Grosvenor-Strathmore WMATA Garage Expansion, Mandatory Referral MR2018026

Completed: 7/5/2018

Request to replace the existing surface parking lot at the Grosvenor-Strathmore Metro Station by expanding the existing 6-story, 1,484-space structured garage by 414-spaces, and reconfiguring the Arts Walk and Kiss & Ride.

Review Basis: Mandatory Referral, MD Land Use Code § 20-301.

1 WEST ELEVATION

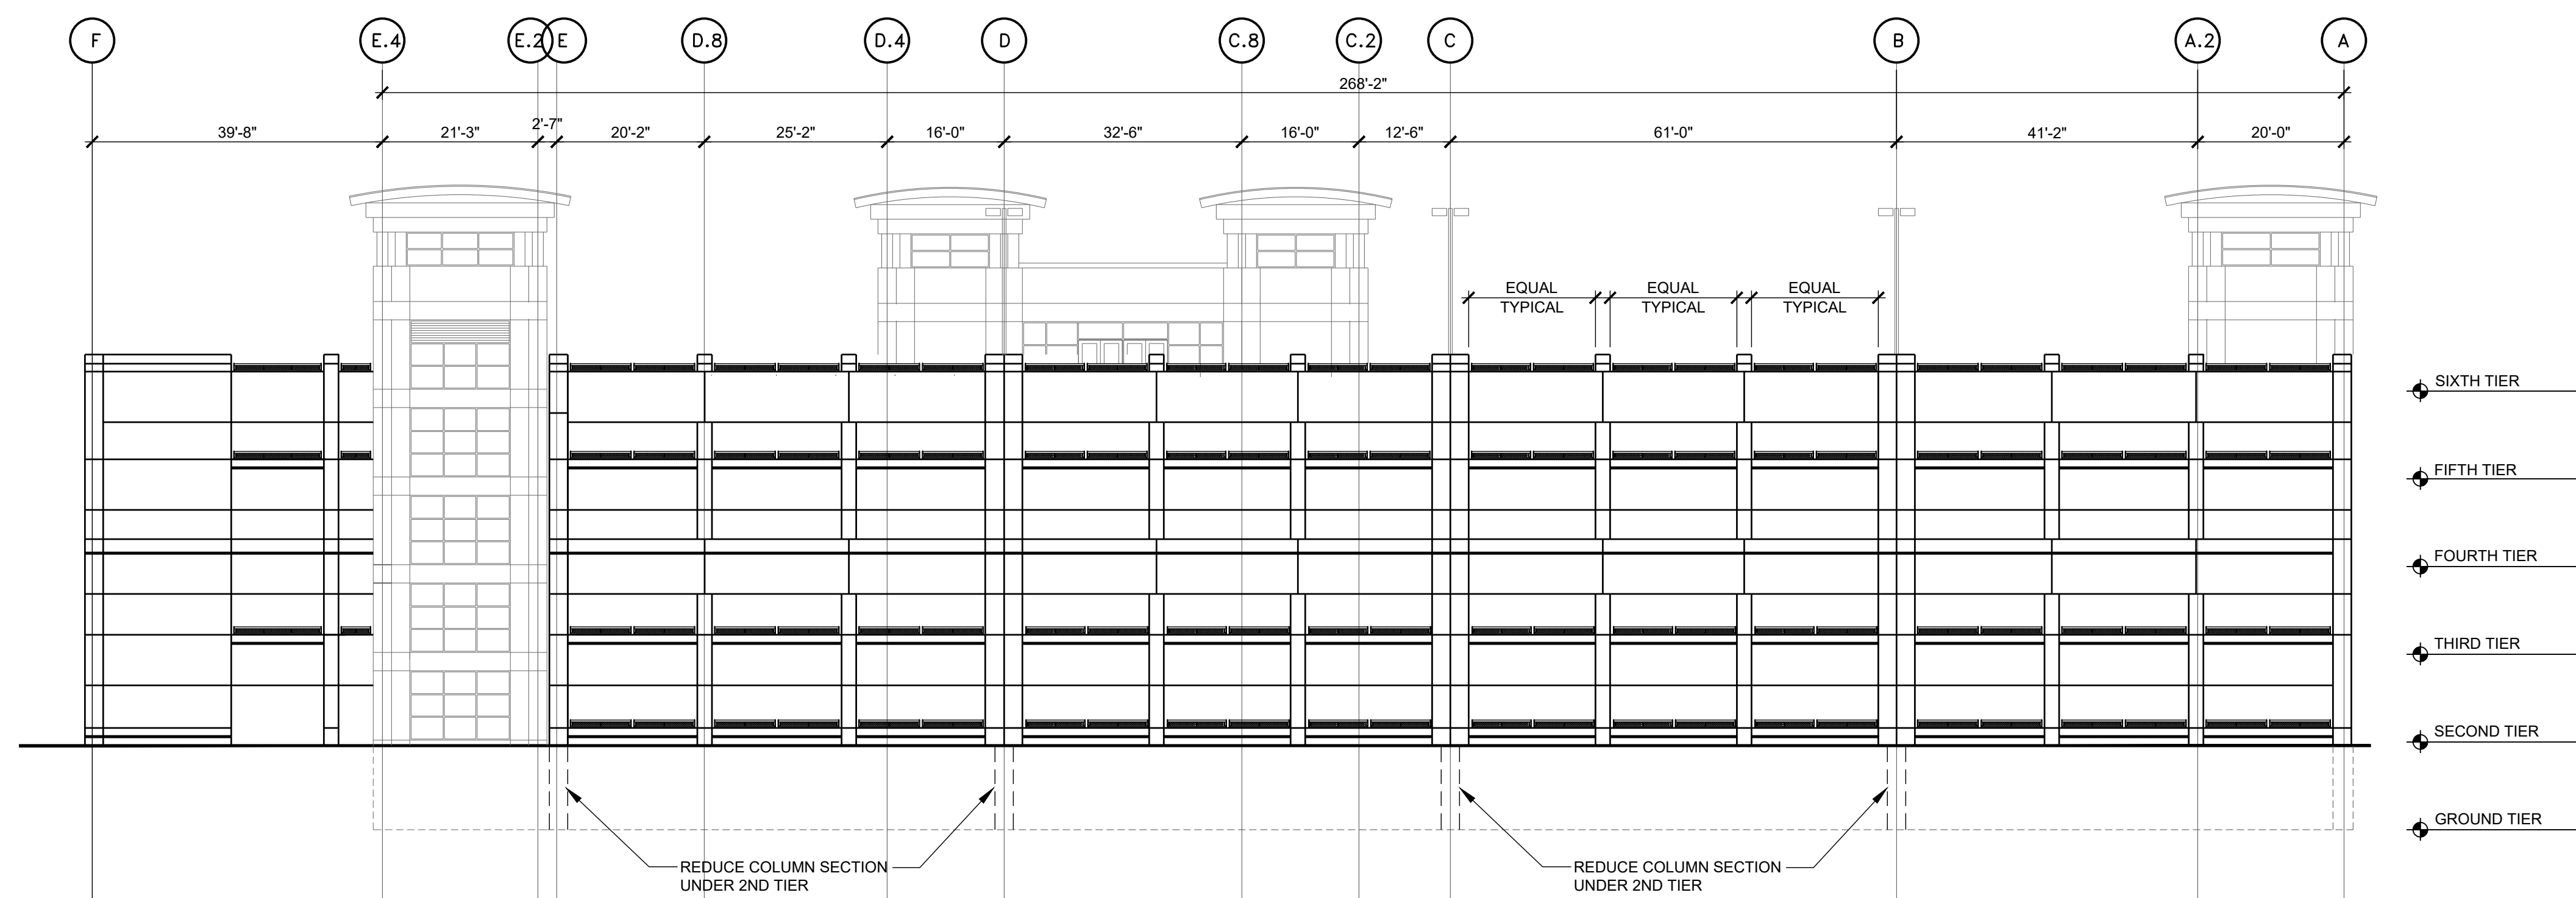
7. Treat the western garage expansion with artistic or architectural elements.
8. Explore opportunities for public recreation on the rooftop of the WMATA garage and/or expansions.

2 SOUTH ELEVATION

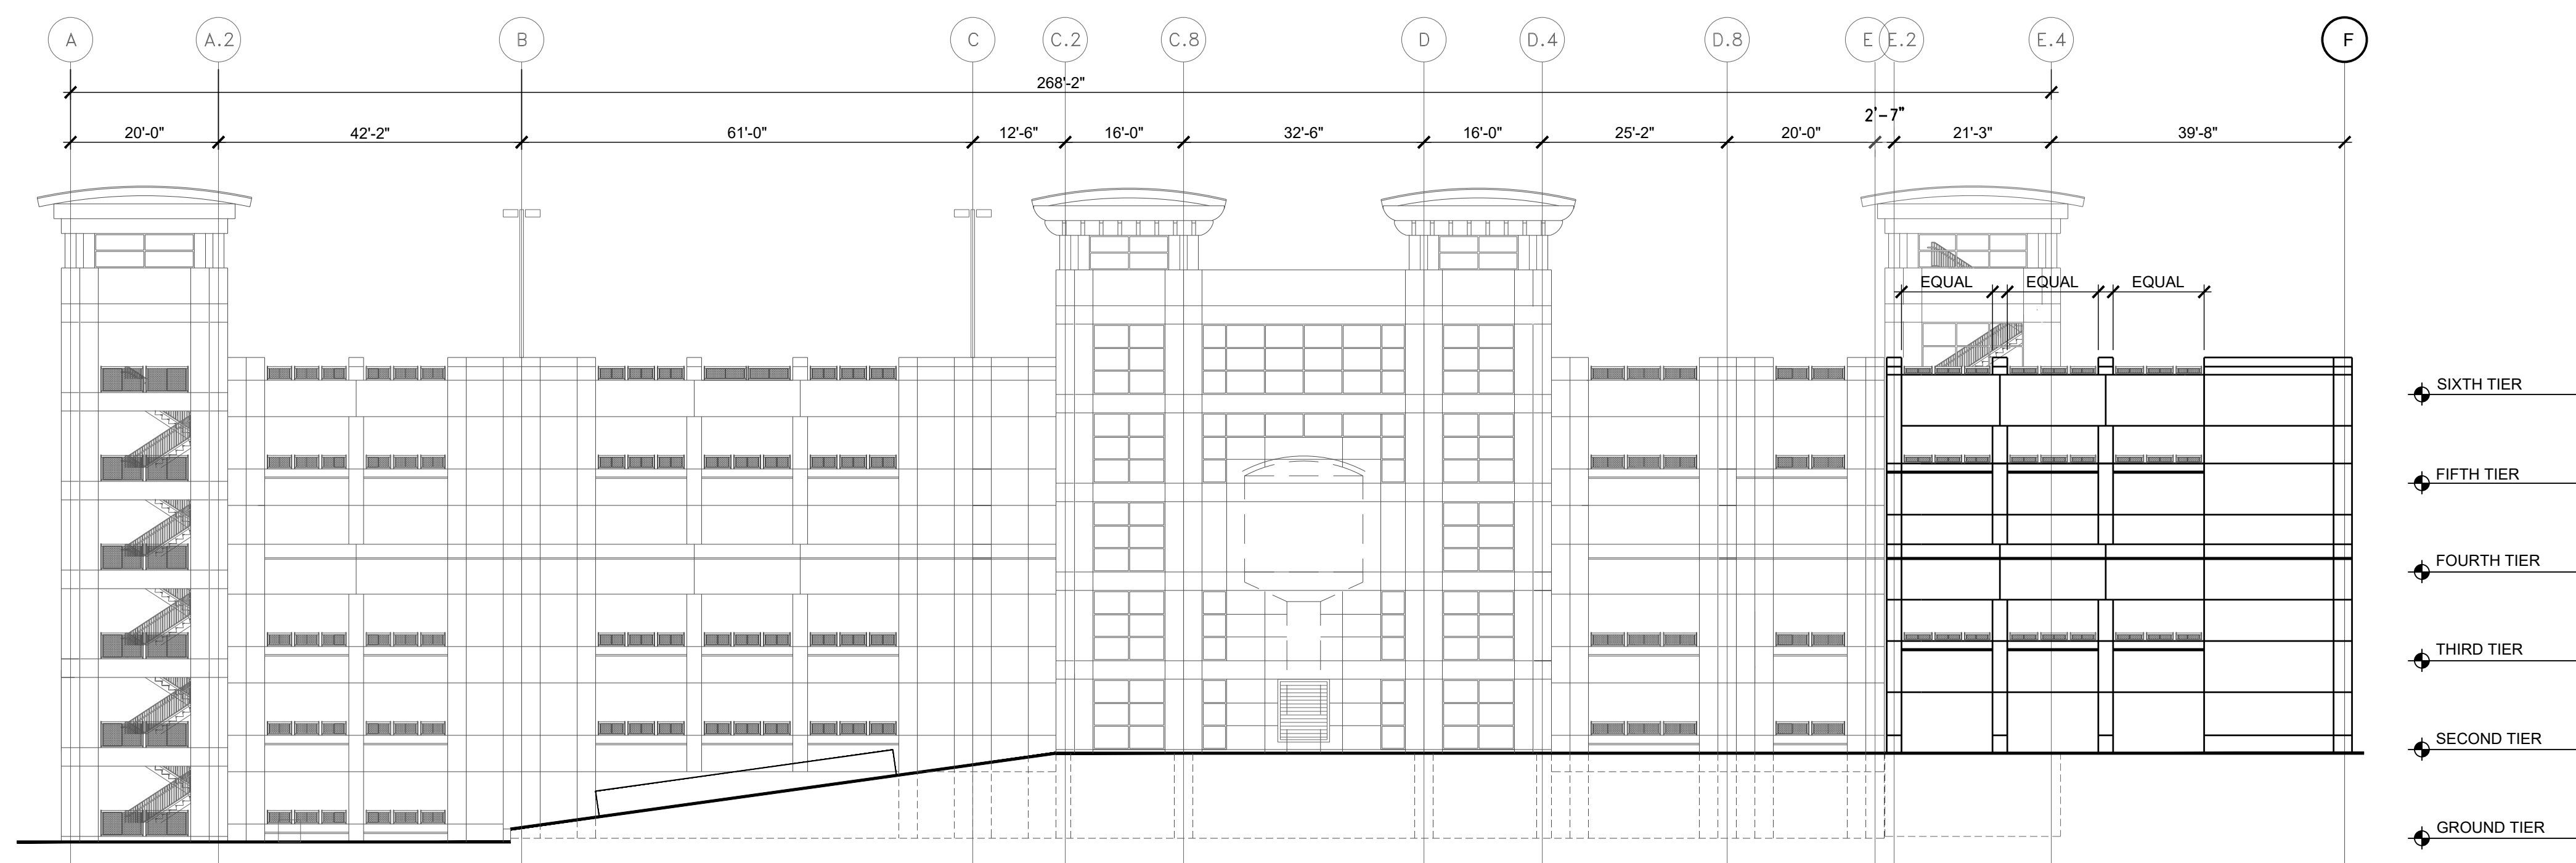
The expansion of the garage does not substantially change the nature of the site. The Applicant's decision to expand the parking garage to the south and west as opposed to previous proposals to expand to the south and east moves the expansion further from existing residential development. However, Staff is concerned about the proposed elevation of the garage expansion facing west. This is a highly visible façade and will be seen from the Kiss & Ride, bus drop off areas, the Metro entrance, and Rockville Pike. Staff recommends screening the western expansion with artistic and architectural elements to make it compatible with the area. Staff expects the southern expansion will be screened by a building as part of future development, so temporary artistic treatments are encouraged along the south façade of the garage.

13. Provide temporary artistic or landscape screening of the south façade of the garage until a building is constructed immediately adjacent to the south façade.
